DUKE POWER COMPANY

October 30, 1985

Re: Catawba Nuclear Station, Units 1 and 2
Docket Nos. 50-413 and 50-414
Proof and Review Technical Specifications

This letter is in response to your October 10, 1985 letter which transmitted the Proof and Review Technical Specifications for Catawba Units 1 and 2.

FIGURE 5.1-2 LOW POPULATION ZONE

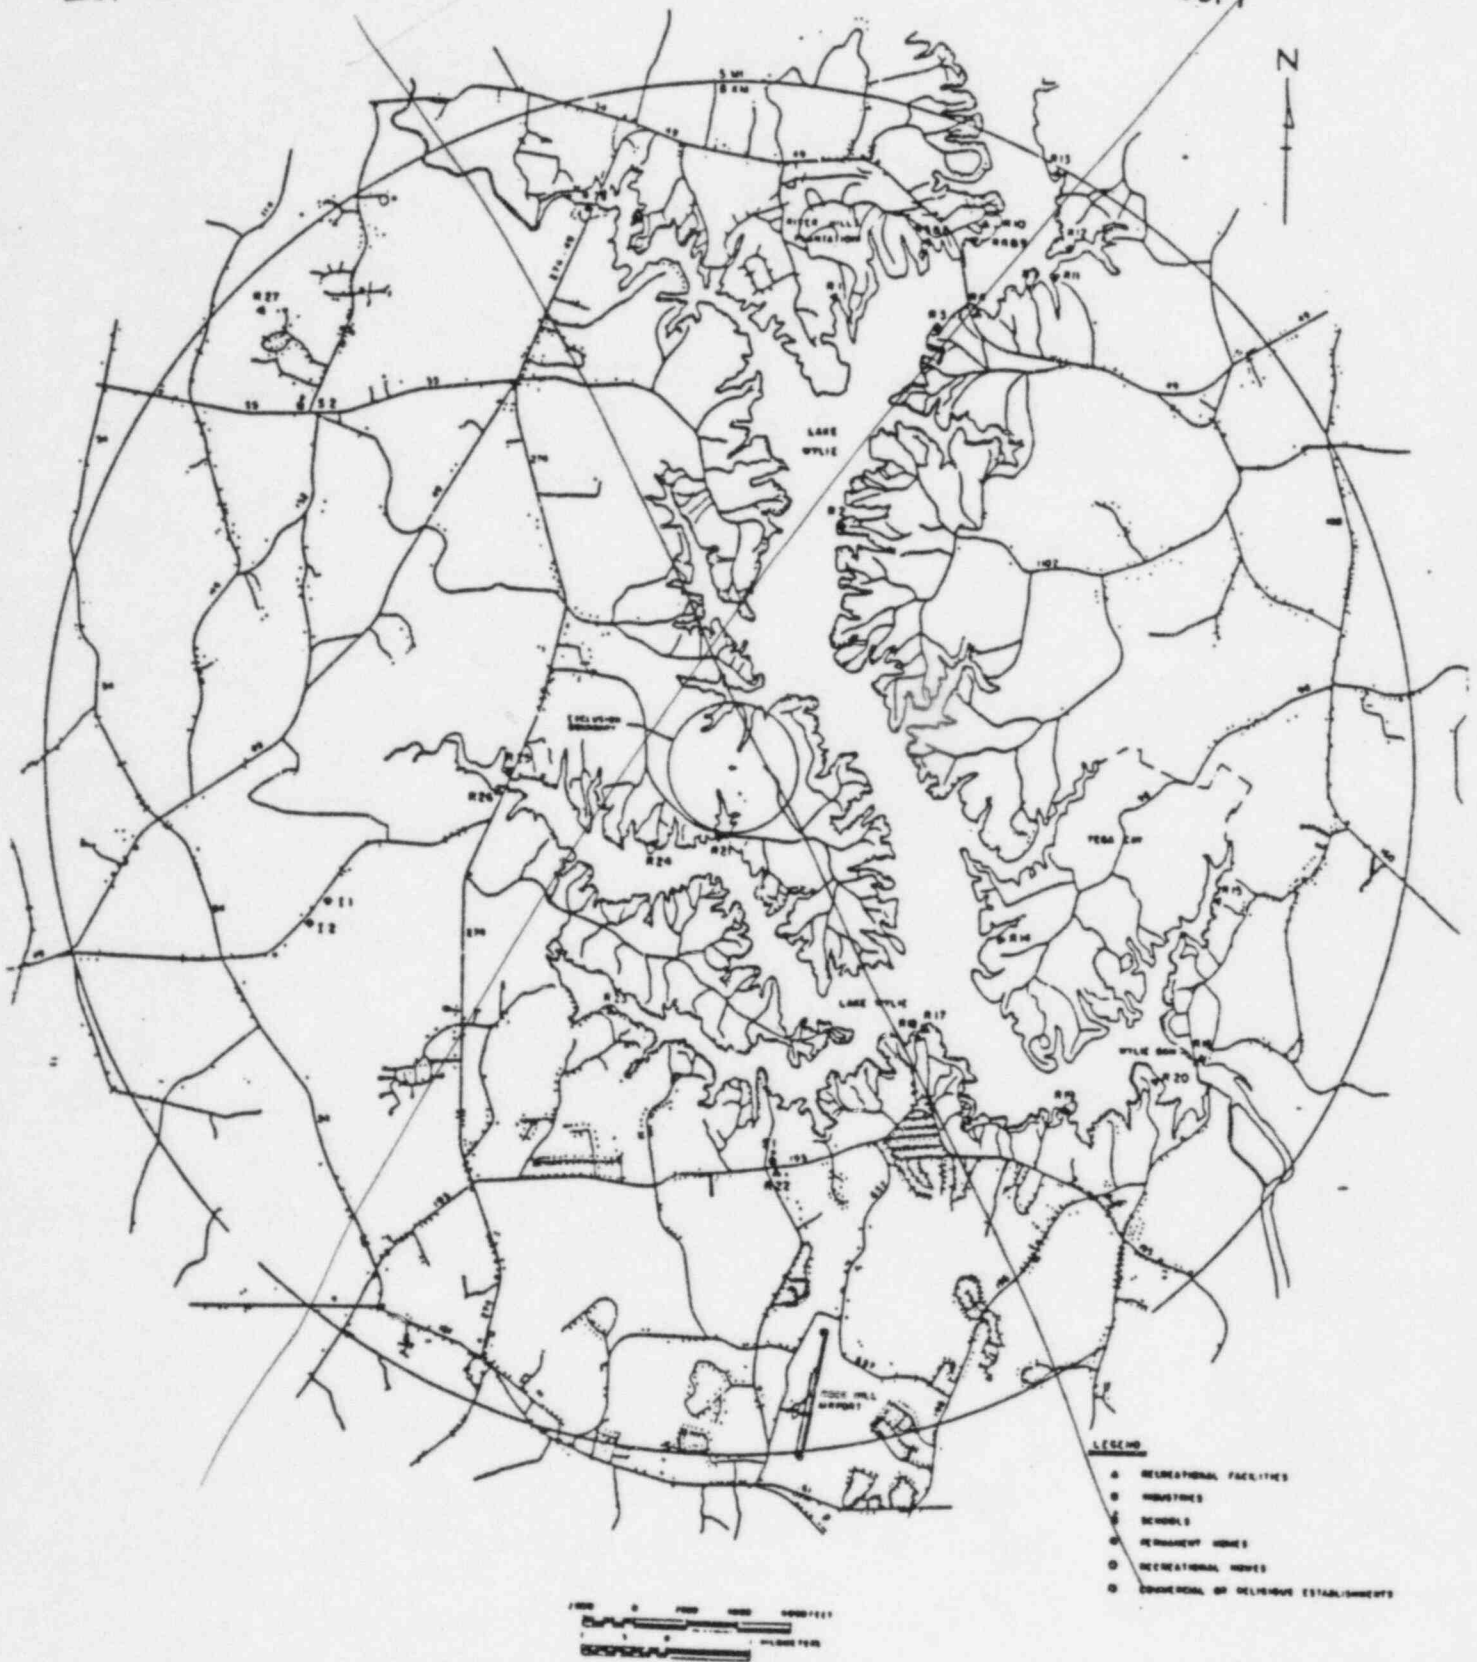
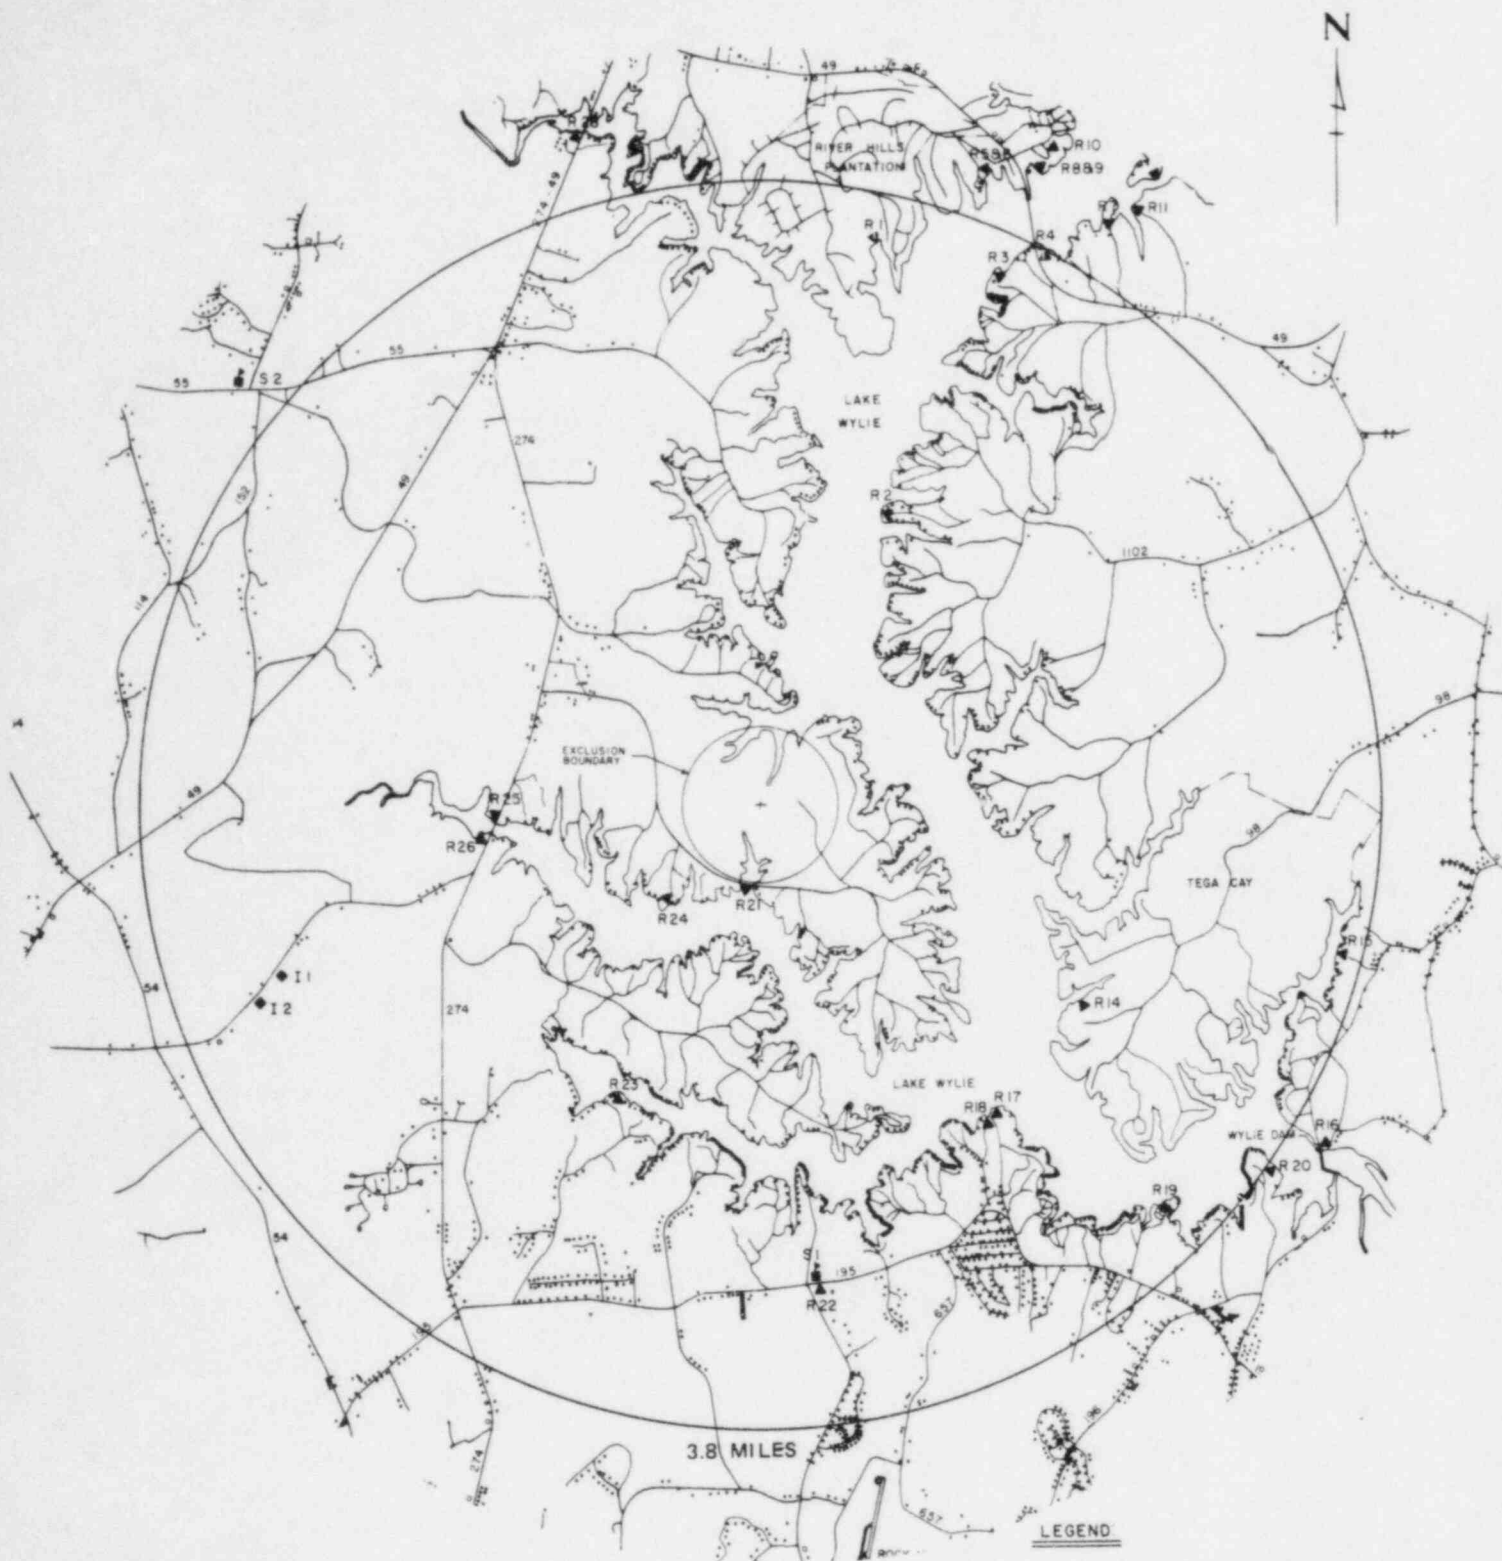
INSERT NEW
LPZ FIGURE

FIGURE 6.2-1
OFFSITE ORGANIZATION

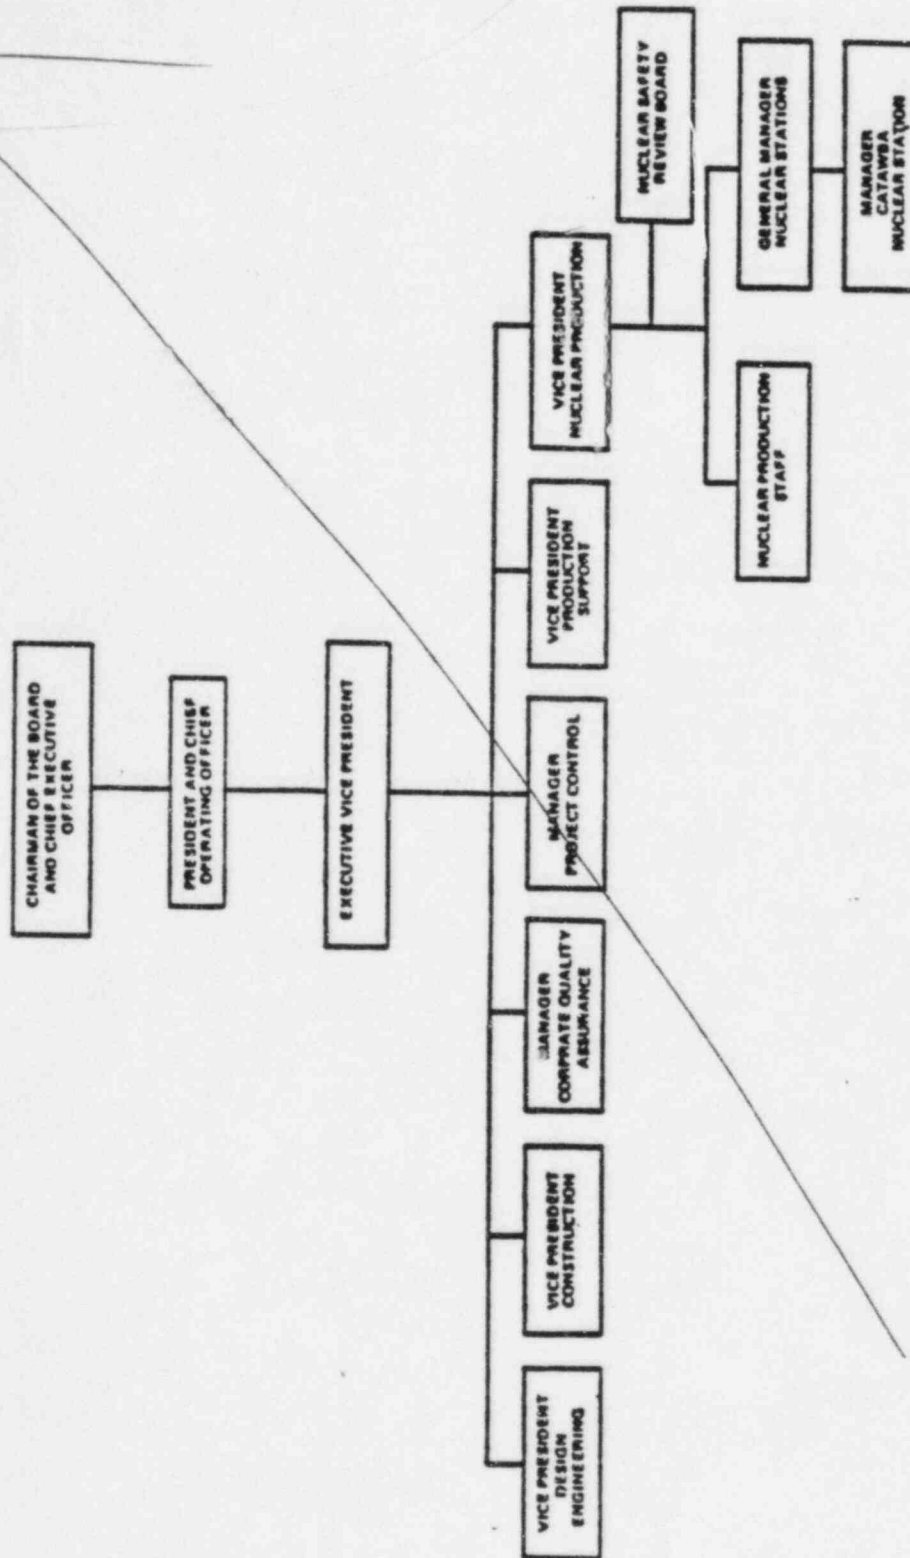
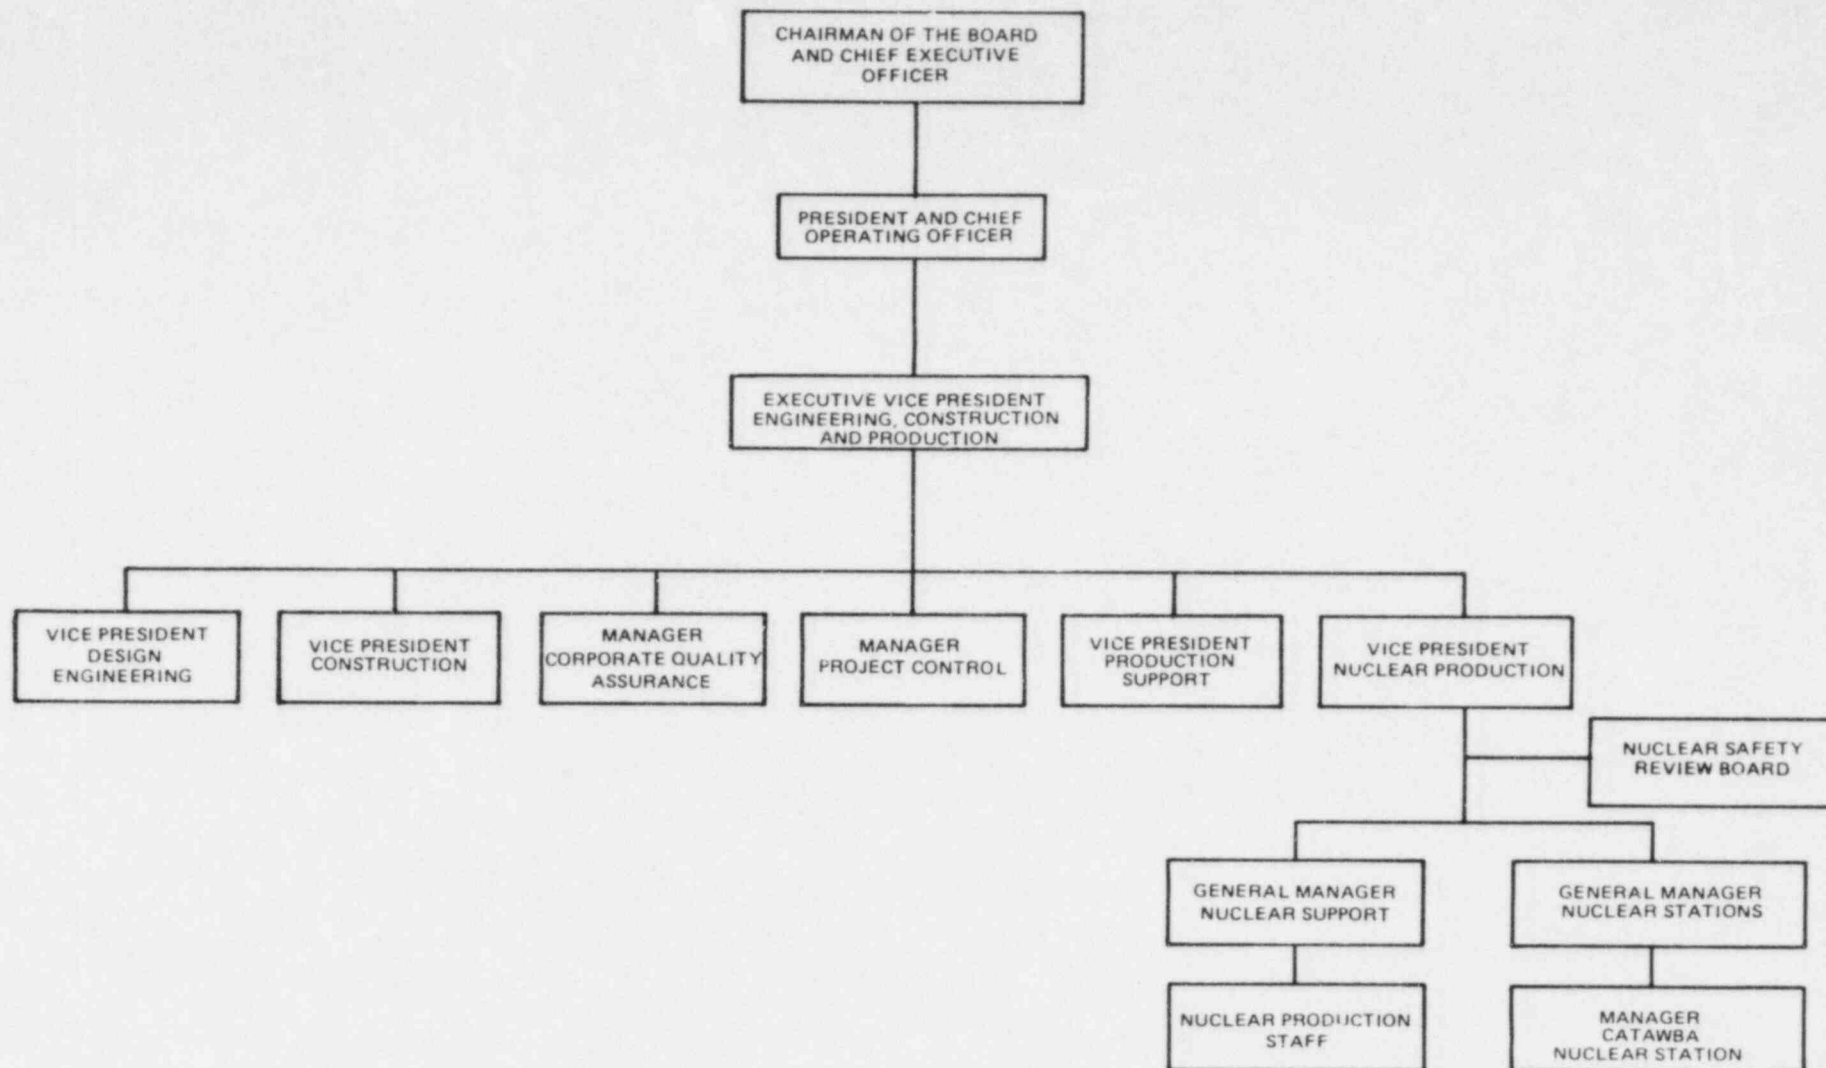
INSERT NEW
OFFSITE ORGANIZATION
FIGURE

FIGURE 6.2-2

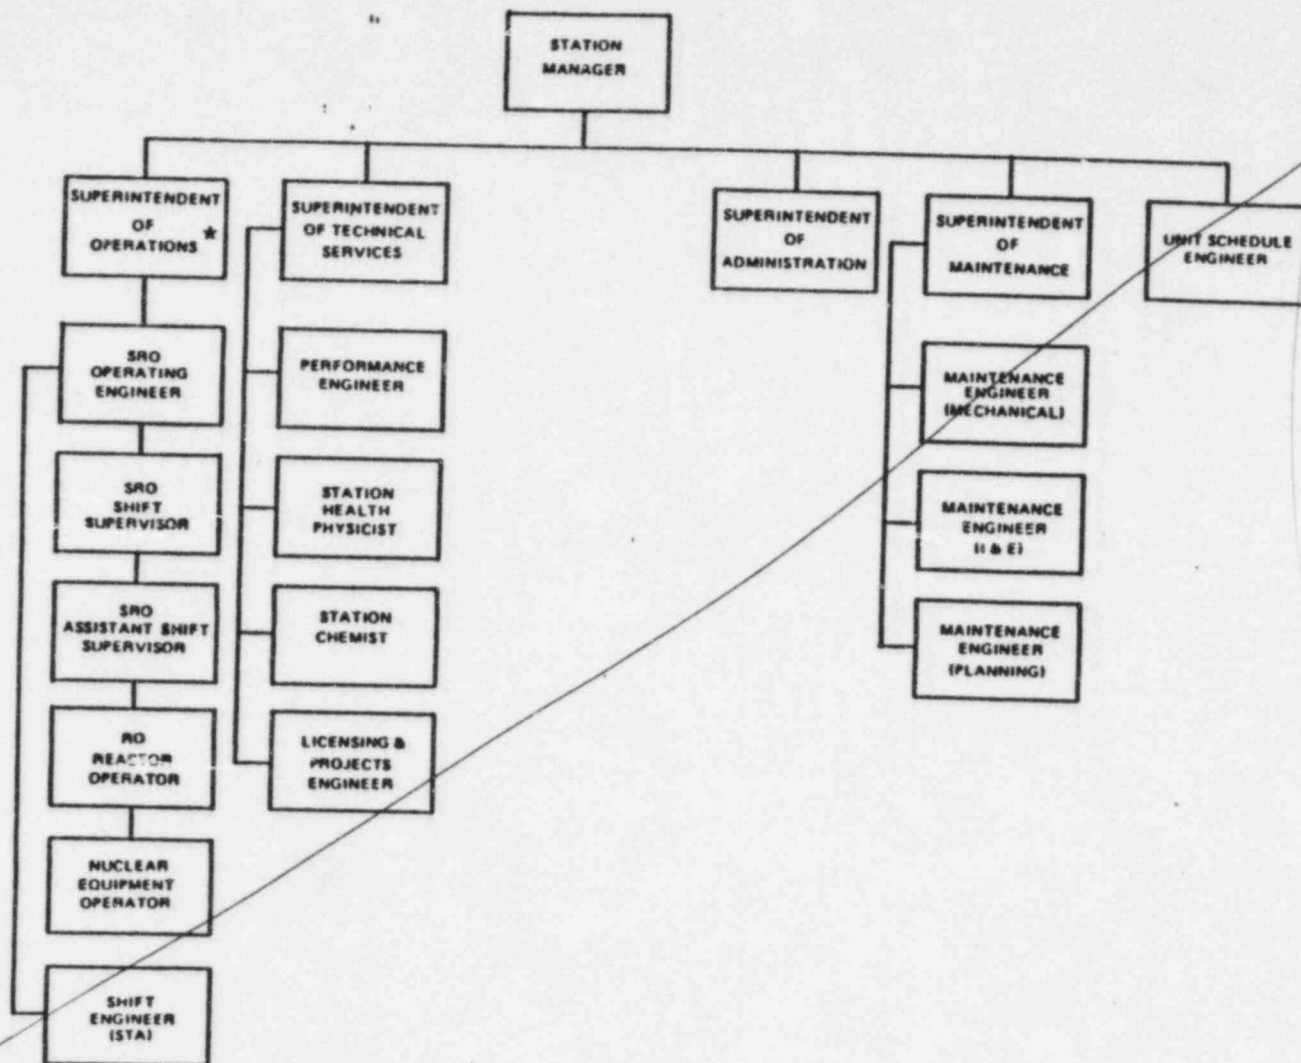
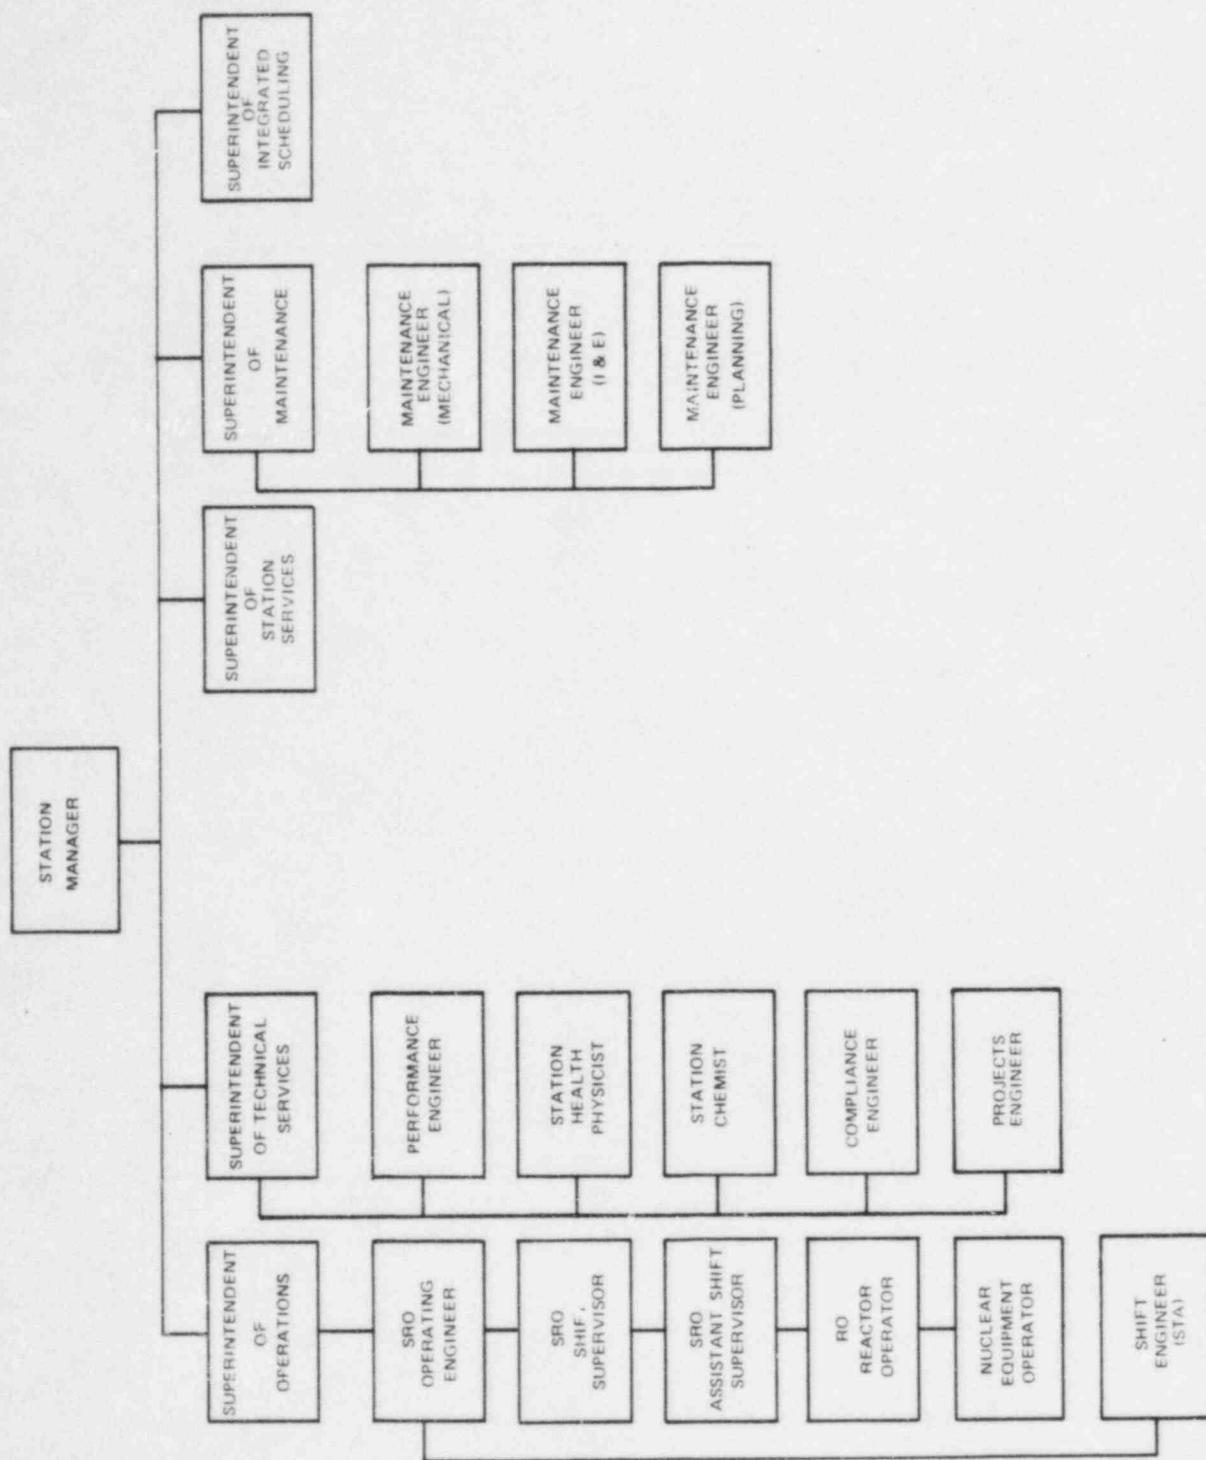
INSERT NEW
STATION ORGANIZATION
FIGURE
